LOCAL PLANNING PANEL AGENDA

ITEM No.	SUBJECT	PAGE No.
1	DEVELOPMENT APPLICATION DA-629/2023 DEMOLITION OF EXISTING STRUCTURES AND CONSTRUCTION OF A 120-PLACE CHILDCARE CENTRE WITH BASEMENT PARKING. LOT 3 DP 602936 123 EPSOM ROAD, CHIPPING NORTON, NSW 2170	4 - 124

Item Number:	1
Application Number:	Application No. 629/2023
Proposed Development:	Demolition of existing structures and construction of a 120-place childcare centre with basement parking.
Property Address	123 Epsom Road, Chipping Norton
Legal Description:	Lot 3 DP 602936
Applicant:	Artmade Architectural Pty Ltd
Land Owner:	Mr M T Brooks and Mrs C M Brooks
Cost of Works:	\$4,607,319.00
Recommendation:	Approved subject to conditions of consent
Assessing Officer:	Ben Paterson

2. APPLICANT RESPONSE – Matters raised by the LPP

Outdoor Play Area 1

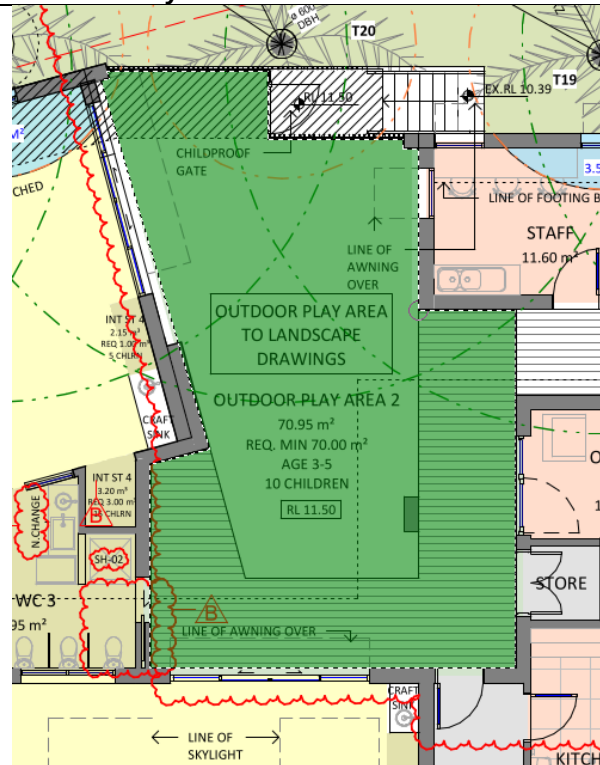
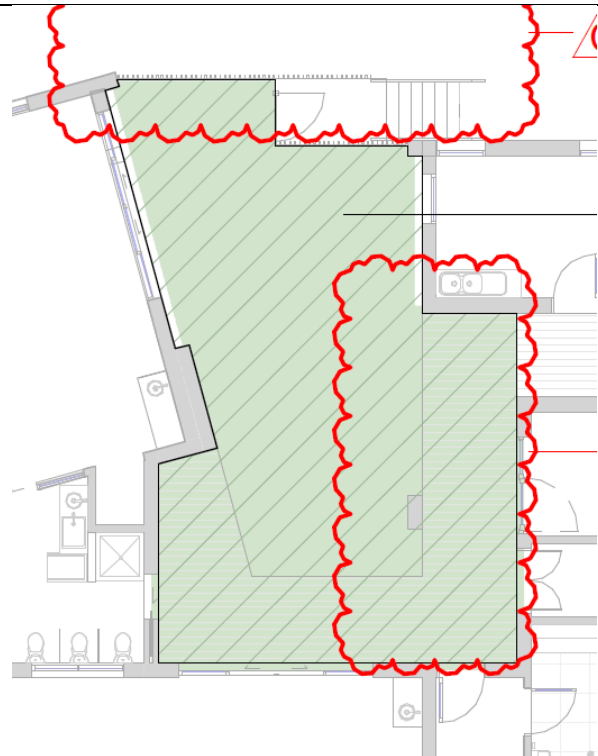
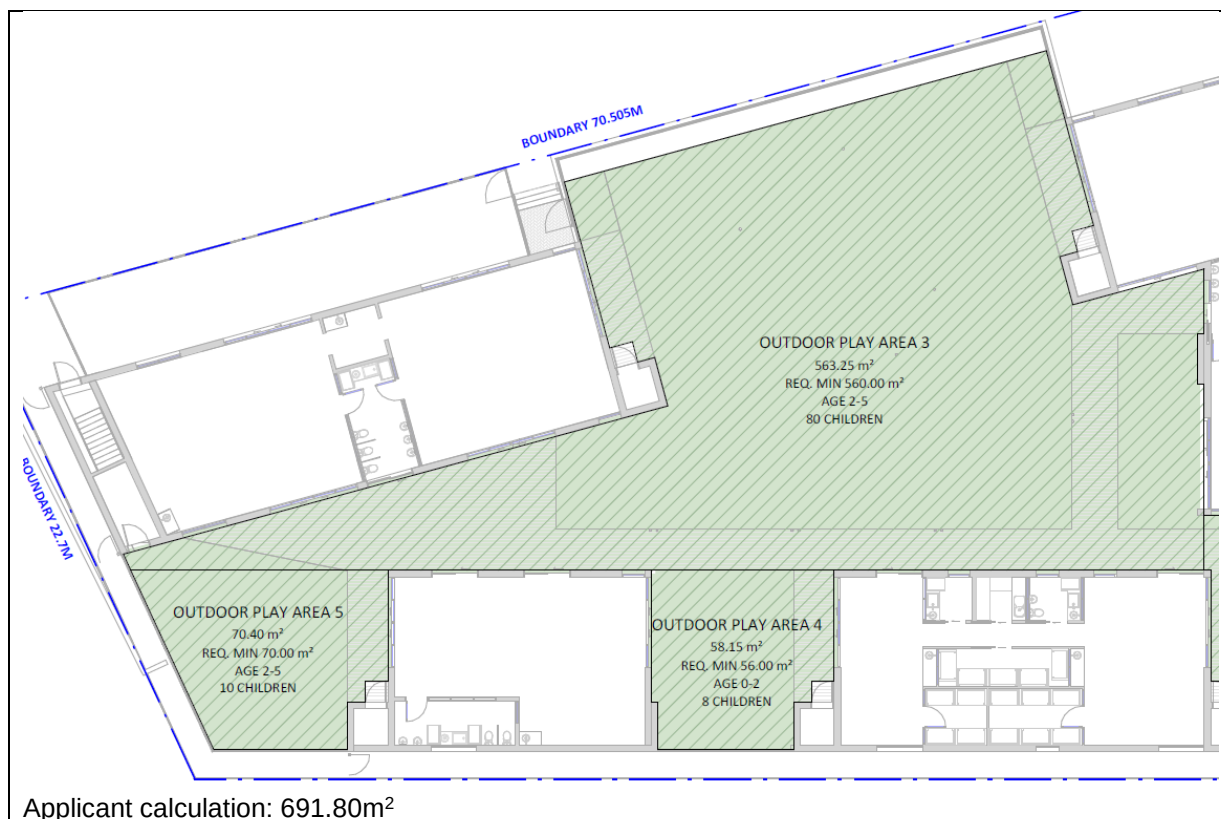
The Panel notes that Council has excluded the planter boxes and trunks of the proposed trees from the calculation of the children's outdoor play area, while the applicant has included them. Council advised the Panel that any variation to the standard needs to be approved by the Department of Education. A Section 4.6 request to vary the landscape area may also be required.

A review of the diagrams on page 20 shows that both Council and the Applicant have excluded dense screen planting from the calculations. The difference in calculations then appears to be that Council have excluded "significant tree trunks". The proposed trees/shrubs in this area are identified by the Landscape Plan as being Crepe Myrtles (2 difference species) which have thin trunks and wider canopies.

The proposed trees do not constitute dense hedges or plantings along boundaries and should not be excluded as encumbered play space. In fact, the CCPG encourages trees as a major element for natural shade in outdoor play areas.

Councils accepts the Applicant's and Local Planning Panel's viewpoint on what is considered unencumbered outdoor area. Pursuant to Regulation 108 of the *Education and Care Services National Regulations* "Calculating unencumbered space for outdoor areas should not include areas of dense hedges or plantings along boundaries which are designed for landscaping purposes and not for children's play". Council accepts that the previously excluded planter boxes that are not located along boundaries can be included in calculations. The Crepe Myrtle trees have thin trunks and wider canopies and will not have a discernible impact on unencumbered outdoor space calculations.

Council's revised unencumbered outdoor area calculations demonstrate compliance as per the amended table below:

Figure 1: Winter solstice 21 June 12pm (existing v proposed overshadowing)

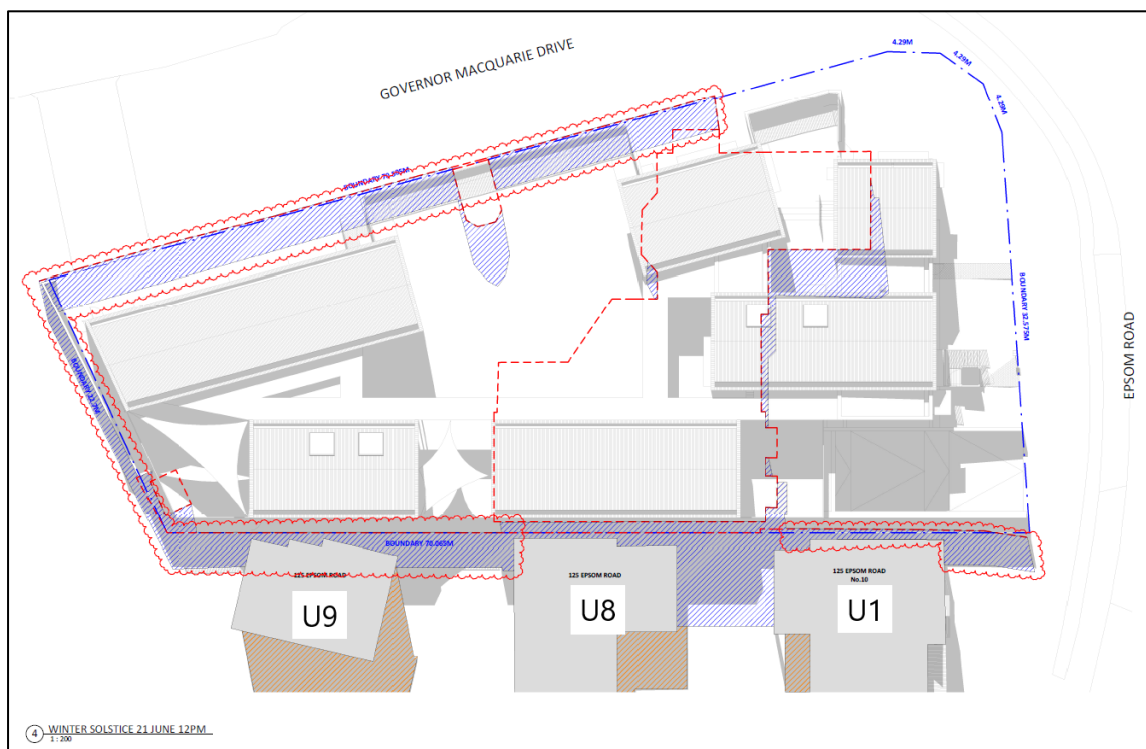
The overshadowing of the three adjoining units (1, 8 and 9 – refer to Figure 11) at No. 125 Epsom Road appears to be of concern, however, it has been demonstrated that the proposed development would not significantly exacerbate this issue. The northern façade of Unit 9 (the western unit) is currently overshadowed for the most part of the day. The proposed development would cause additional overshadowing during the early hours (between 9am and 10am) to the rear of the site, however the unit would retain suitable solar access to its private open space (POS) between 11am and 5pm.

The northern façade of Unit 8 (the centre unit) is also currently overshadowed for the most part of the day. The POS is located to the eastern side of the dwelling and currently does not achieve suitable solar access. Whilst the proposed overshadowing plans demonstrate that solar access would remain insufficient, a minor improvement has been demonstrated due to the proposed development. The northern façade of Unit 1 (the eastern unit) is currently overshadowed for the most part of the day and the POS currently receives limited solar access; however, the proposed development demonstrates that negligible additional overshadowing would be caused.

This variation was discussed at the LPP, and no objection was raised by the panel.

Figure 2: Proposed location of crash barrier highlighted in yellow.

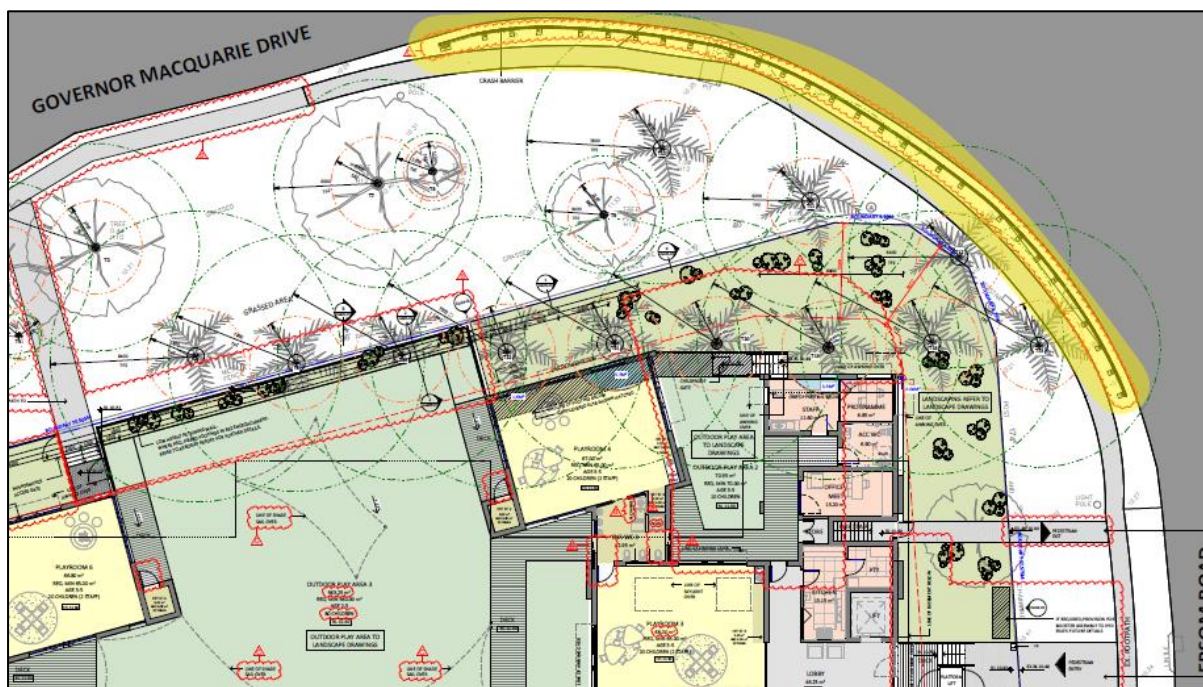
The Panel notes concerns related to safety, particularly the potential for accidental vehicular entry into the site. The Applicant is to submit amended plans for the boundary fences adjacent to Governor Macquarie Drive and Epsom Road. The fences are to be engineered to resist the impact of vehicles in accordance with relevant Australian Standards. The design may also incorporate other safety barrier systems in addition to the boundary fences.

As noted above, the Applicant was encouraged to include a safety barrier of sufficient length at the kerbside near outdoor play area 2, in accordance with TfNSW standards. This option was considered more beneficial for the wider community as it would also protect the footpath at this location. Amended plans adequately address this concern.

Council's Traffic & Transport Officer, in consultation with Council's Road Safety Officer, determined that an alternative safety barrier system would provide an improved outcome. The Applicant was encouraged to include a crash barrier at the kerbside near Outdoor Play

Area 2, in accordance with TfNSW standards. This option was considered more beneficial for the wider community as it would also protect the footpath at this location. Council is satisfied that the amended plans demonstrate this recommendation has been incorporated into the proposal.

Figure 3: Basement extension highlighted in yellow

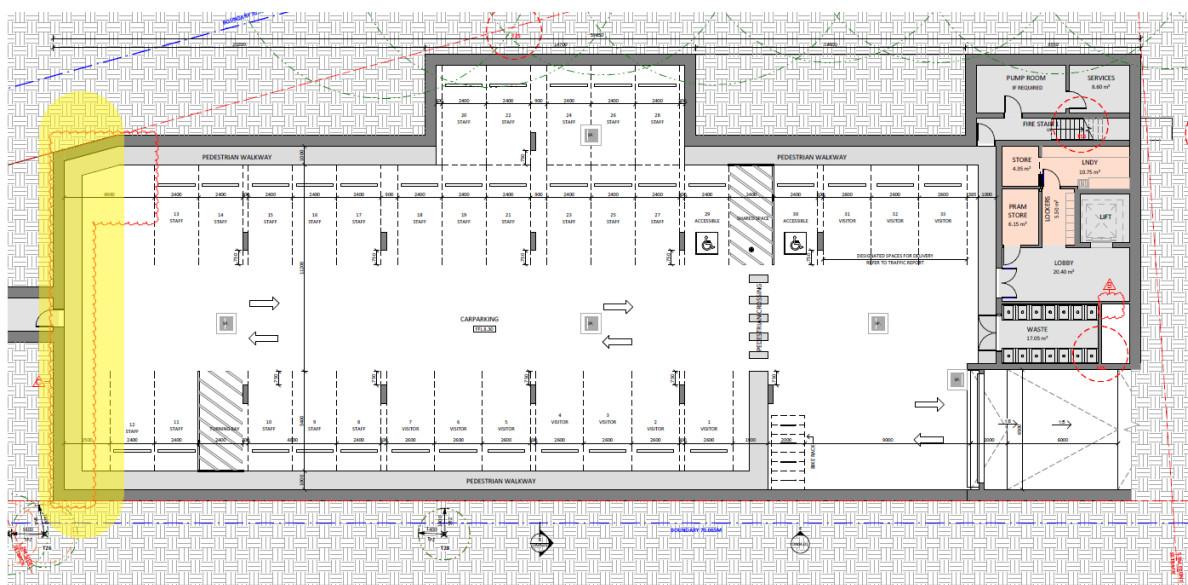
- Amended plans are to illustrate increased basement extents to demonstrate that there is no overlap of turning paths and pedestrian walkway.
- Council accepts the panels viewpoint that the visibility of passing vehicles from Playrooms 4 and 5 would not pose a detrimental impact on amenity. Notwithstanding, the Applicant has proposed a 1500mm translucent film to windows facing Governor Macquarie Drive.

Amended plans illustrate that the basement has been extended further west to demonstrate that there is no longer an overlap of turning paths and pedestrian walkway when using Parking Spaces Nos 12 & 13.
